# SNS Low Level RF Control System Team Response to the Reviewer Comments of the Dec. 17 Hardware Design Review

31 Jan 2003

The LLRF Team has prepared this written response to the Reviewer Comments that were received following the Dec. 17 hardware design review at Los Alamos. The reviewer comments have been grouped in six categories. The persons responsible for addressing the comments are identified under the category headings, with the principal author's name underlined. The text is color coded according to the following color key:

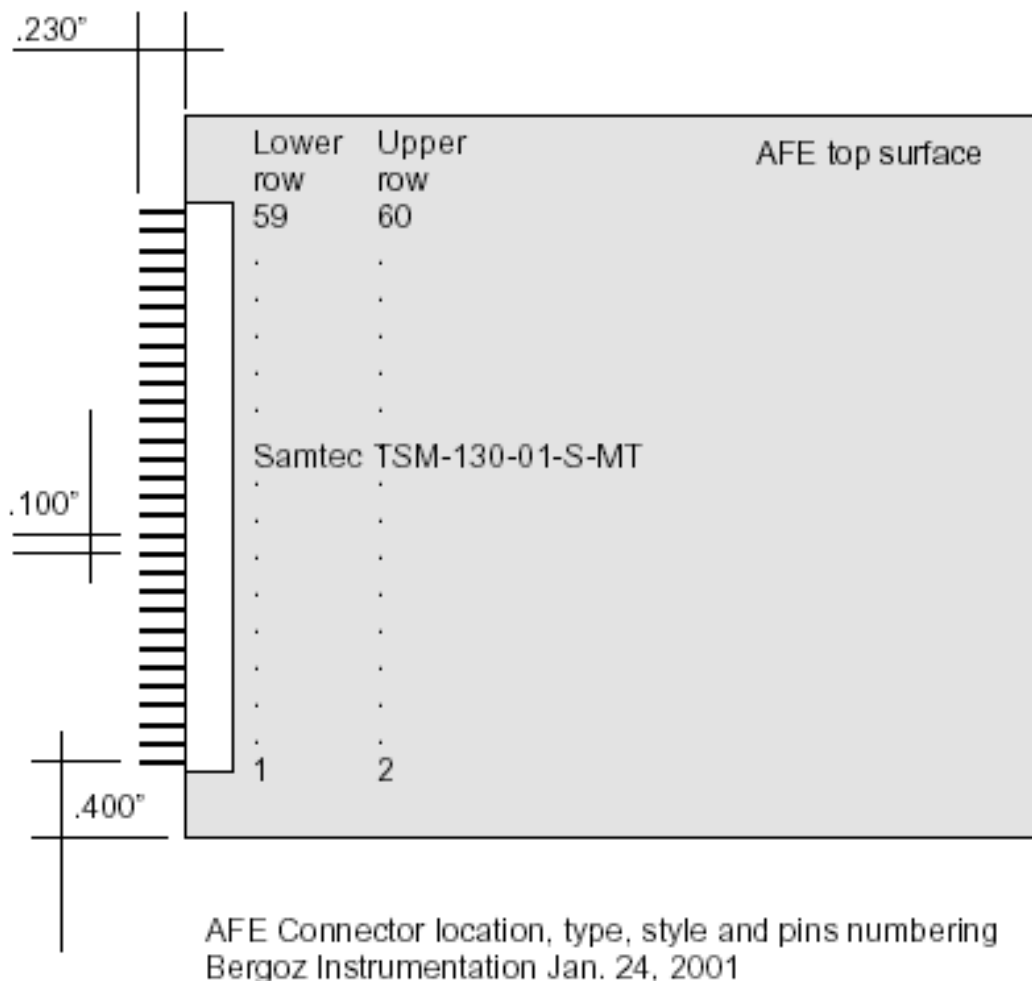
1. Identical to footprint for Beam Position Monitor presently being provided by Bergoz, (although SMA connectors can be moved slightly if necessary).  
Overall board size and edge connector location should not change. See below.
